CITY OF LAKE GENEVA PLAN COMMISSION

MONDAY, JUNE 19, 2023 - 6:00 PM

To: Fred Walling, Zoning Administrator
Date: April 20, 2023
Revised April 20, 2023

Subject: PIP REVIEW – 1120 S. Lakeshore Drive (Units #1-#4 and #28-#31)
Kapur Project Number 22.0160 Phase 17 – Recommendation for Approval
(revised to include missing tax parcels)

- SHEET 1 - GENERAL DEVELOPMENT & PRECISE IMPLEMENTATION PLAN
SHEET 2 - CONSTRUCTION DETAILS
SHEET 3 - CONSTRUCTION SPECIFICATIONS

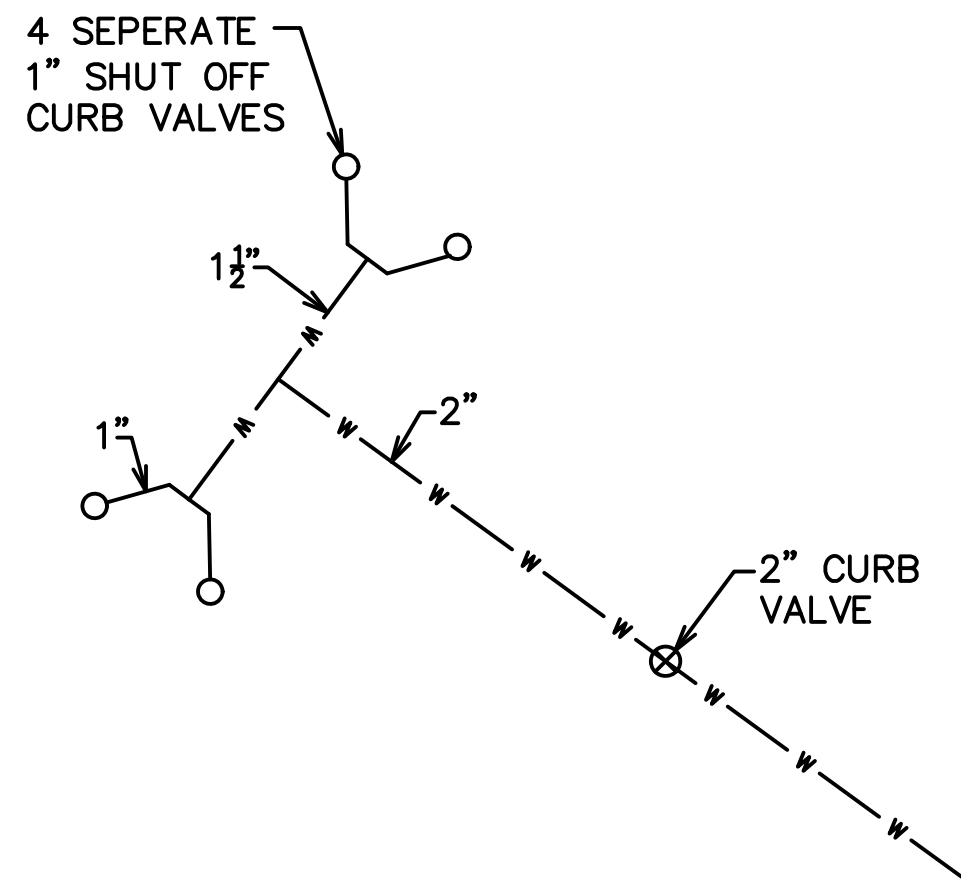
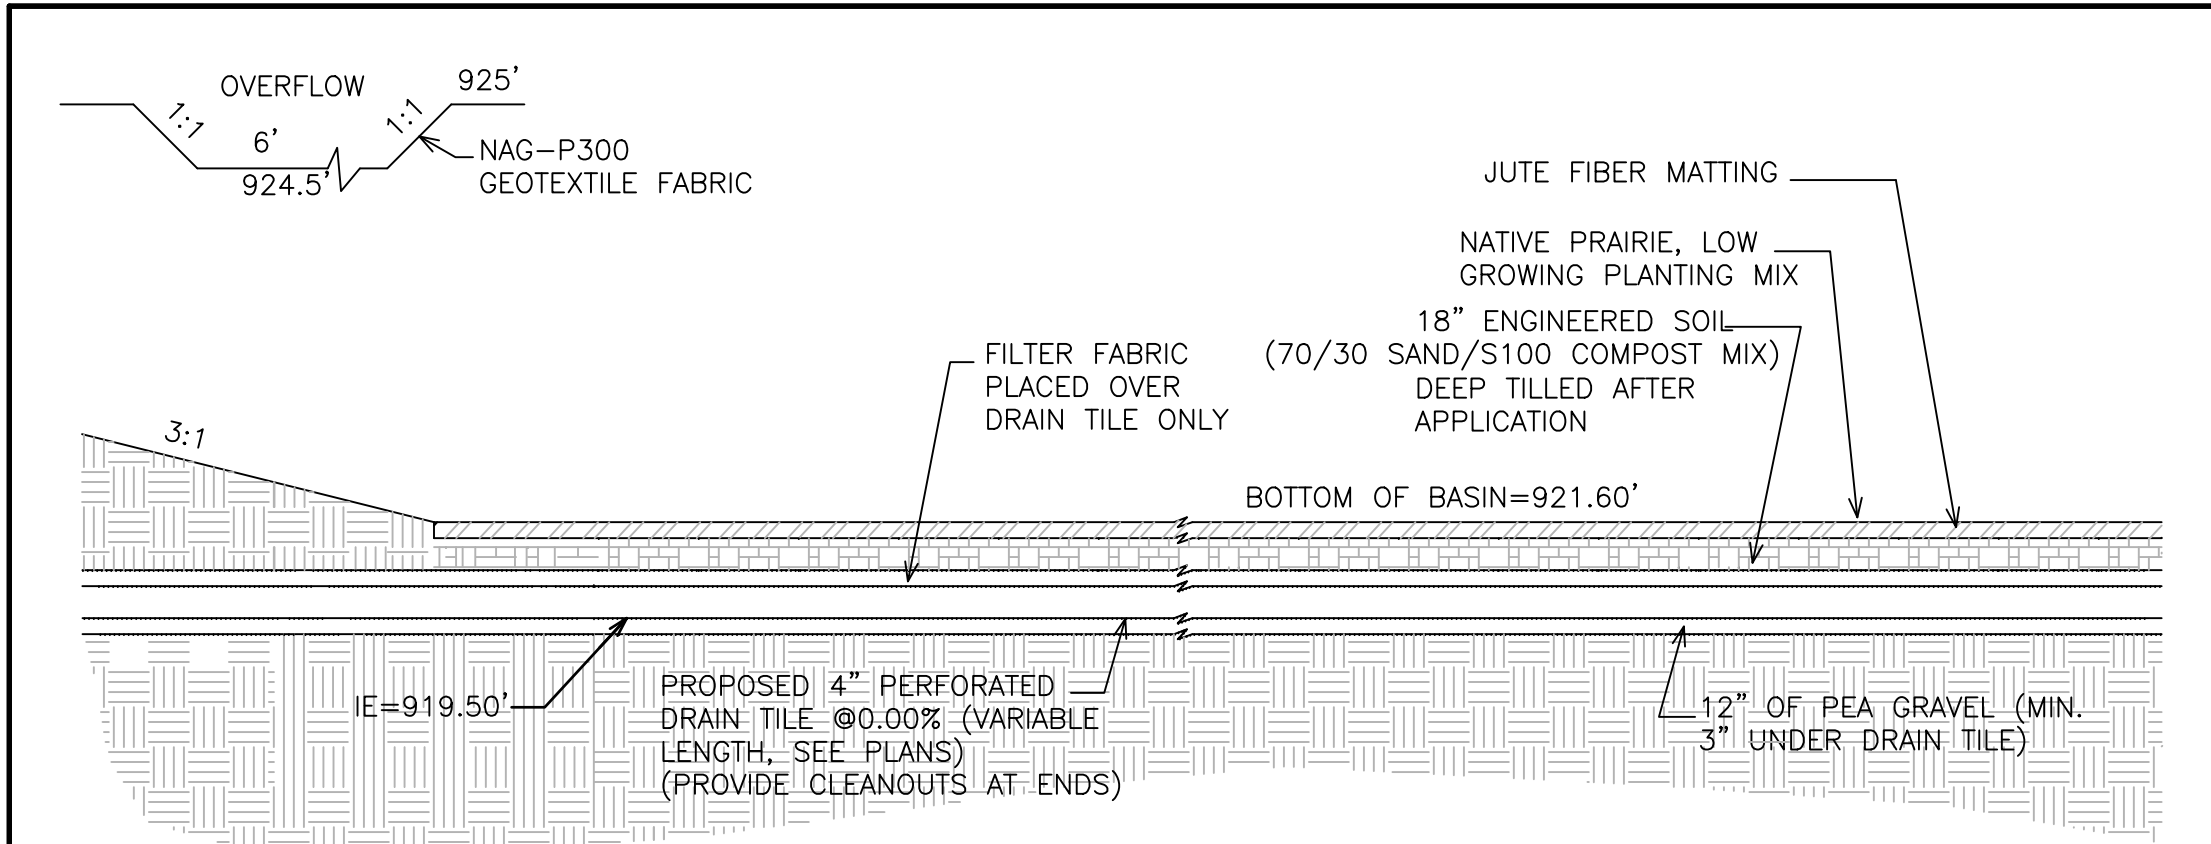
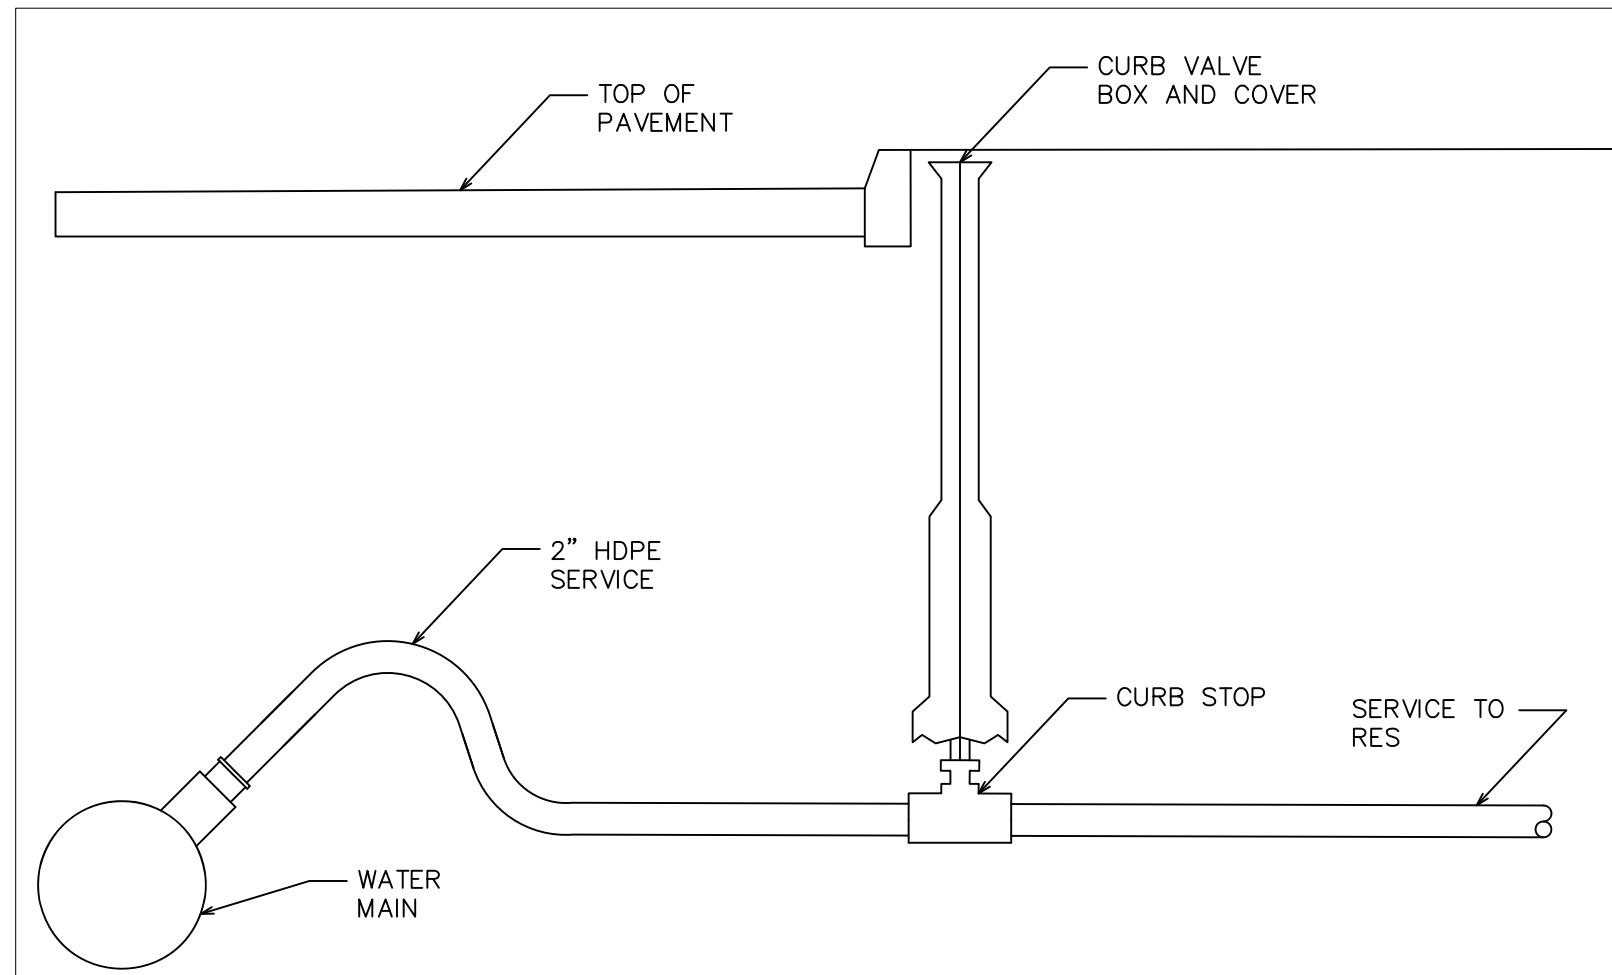
1. The plan shall be revised to show the water service connection elevations and distances from the existing hydrant. This information is required for each water service connection.

2. There appears to be a conflict with the water services to Units 28-29 and the proposed storm drain. The yard grade is 939 where the water lateral invert is 933 and the invert of the storm pipe is at 933.5. A note must be added to the plan requiring a minimum of 18-inches vertical separation between the bottom of the storm drain and the top of the water lateral pipe. It is recommended that water services be insulated at the drainage pipe crossing.

3. Construction details for the drainage pipe installation and catch basins are required on the plan set.
4. The spillway for the proposed biofiltration basin shall be directed to the Lagrange Drive Right-of-Way. The stormwater management report indicates the spillway will be installed at 927.99 and location of the spillway must be recorded on the as-built plans. This will require grading to the retaining wall on the west property line up to an elevation greater than 928.

| SHEET 1 - | GENERAL DEVELOPMENT & PRECISE IMPLEMENTATION PLAN |

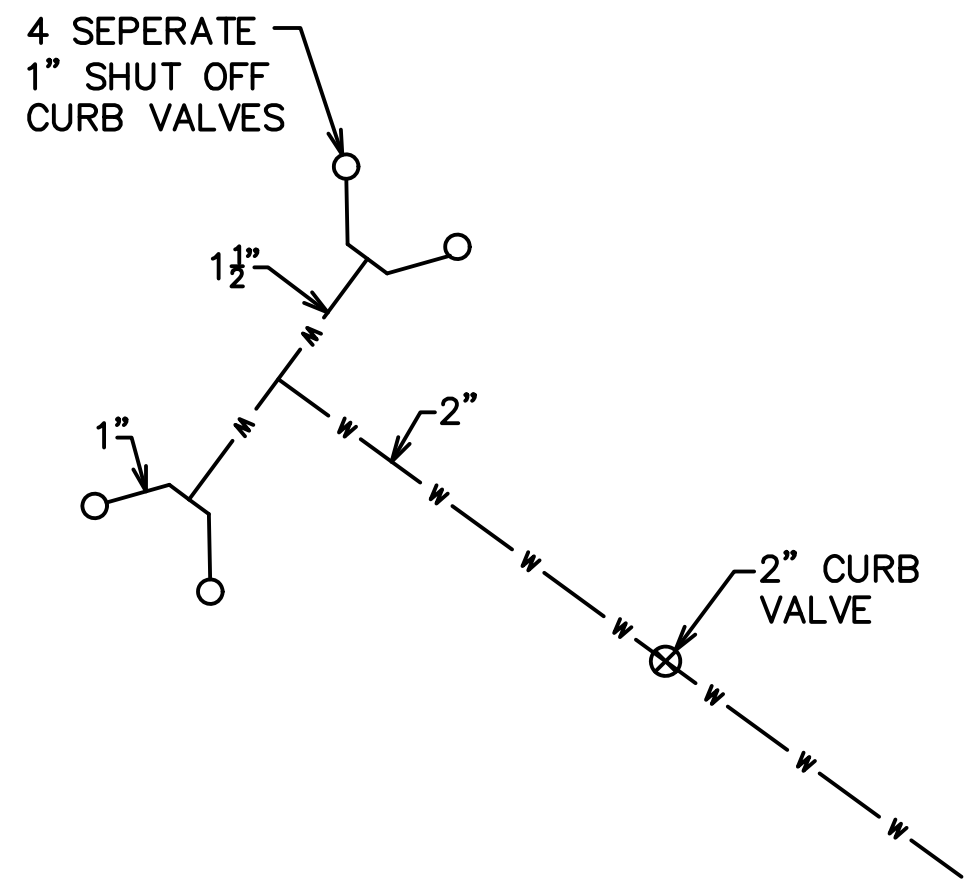
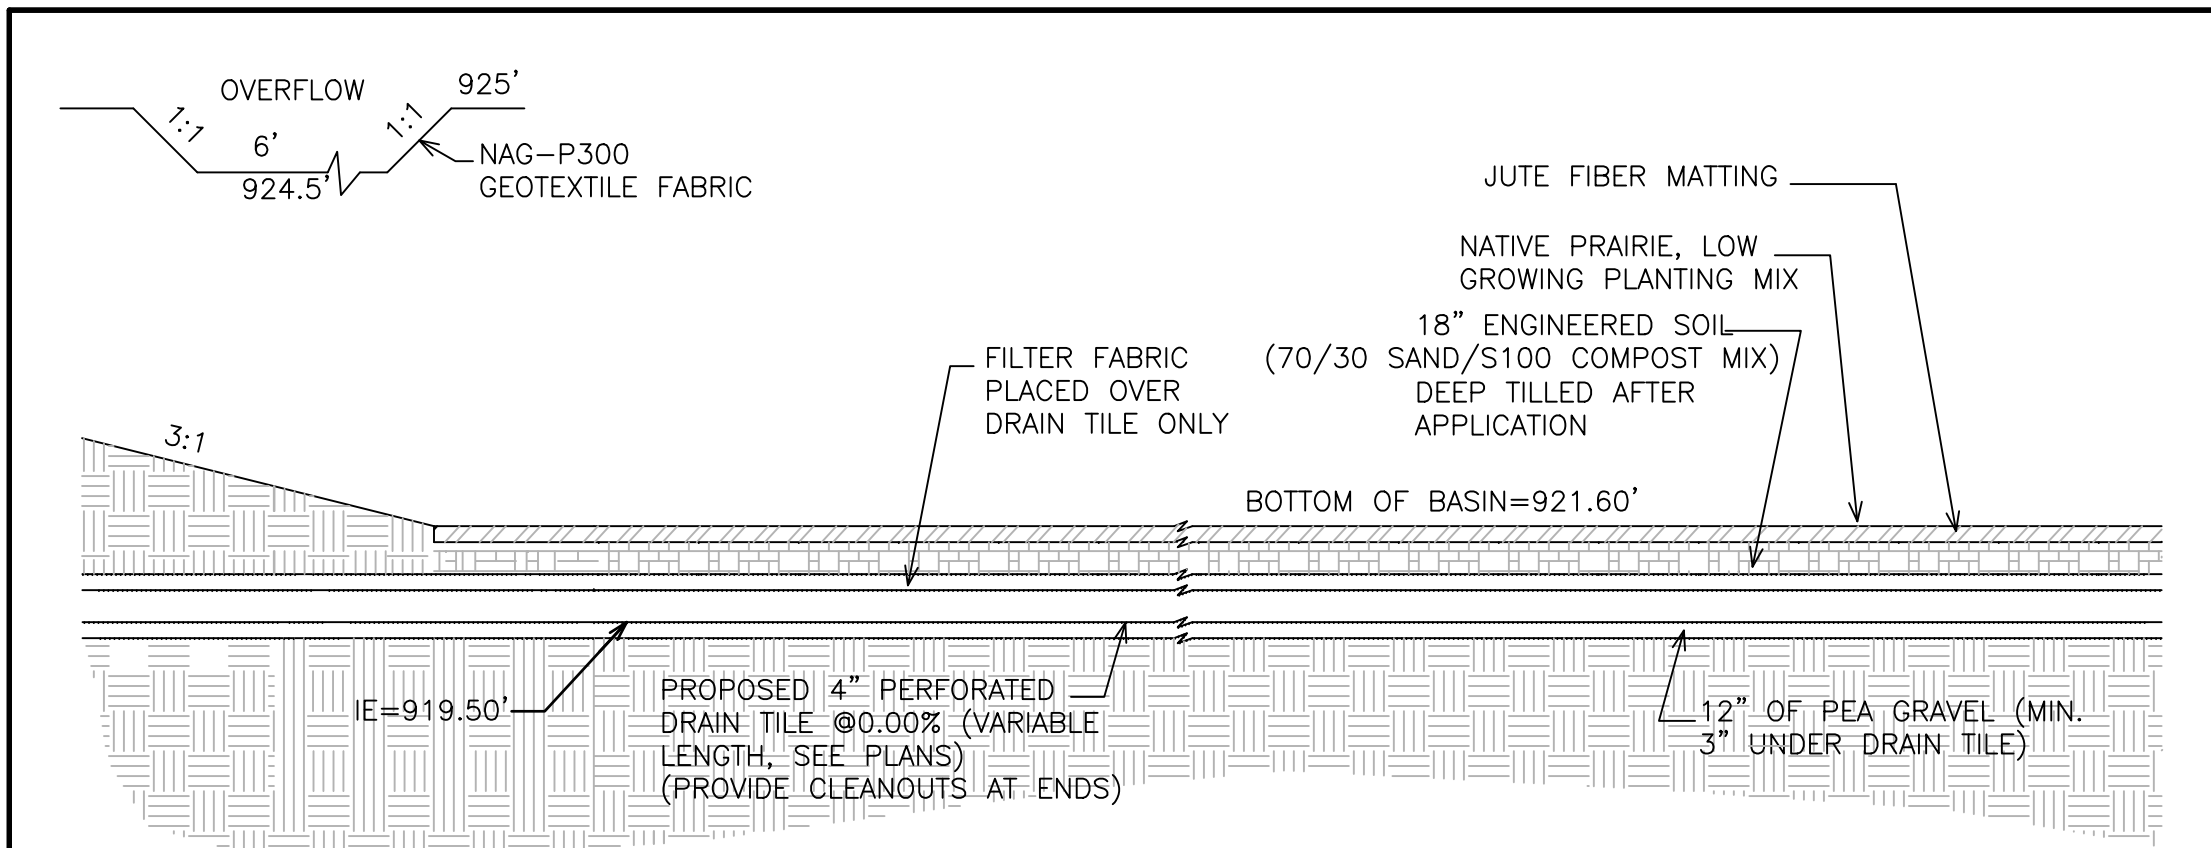
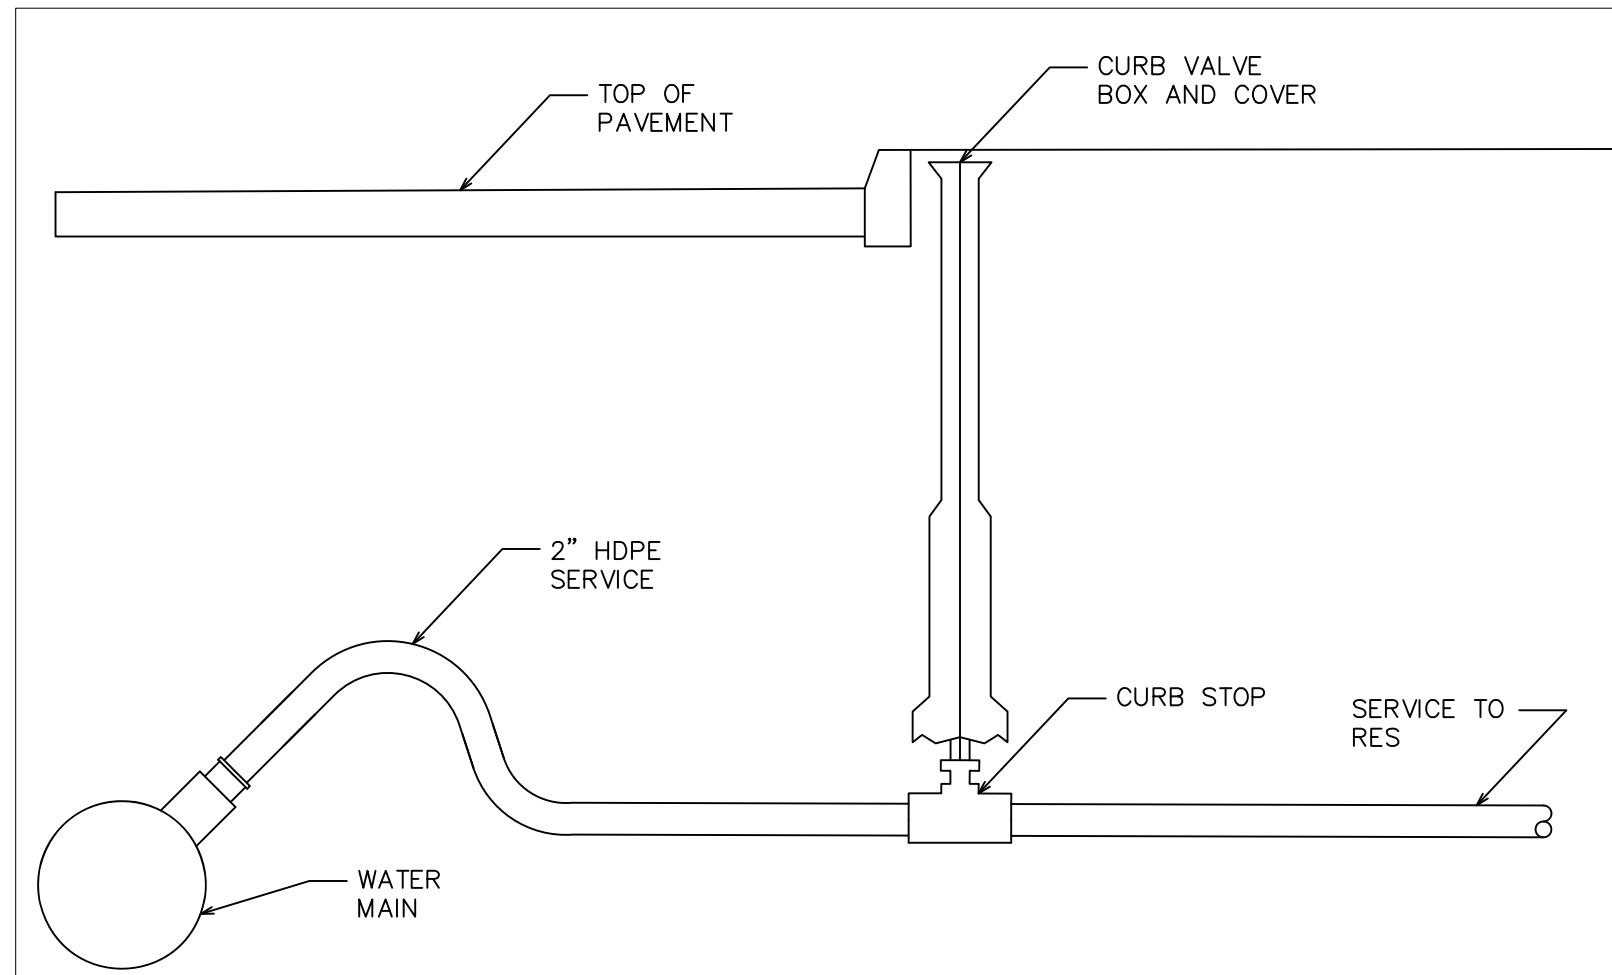
5. The plan shall be revised to show the water service connection elevations and distances from the existing hydrant. This information is required for each water service connection.
6. Construction details for the drainage pipe installation and catch basins are required on the plan set.
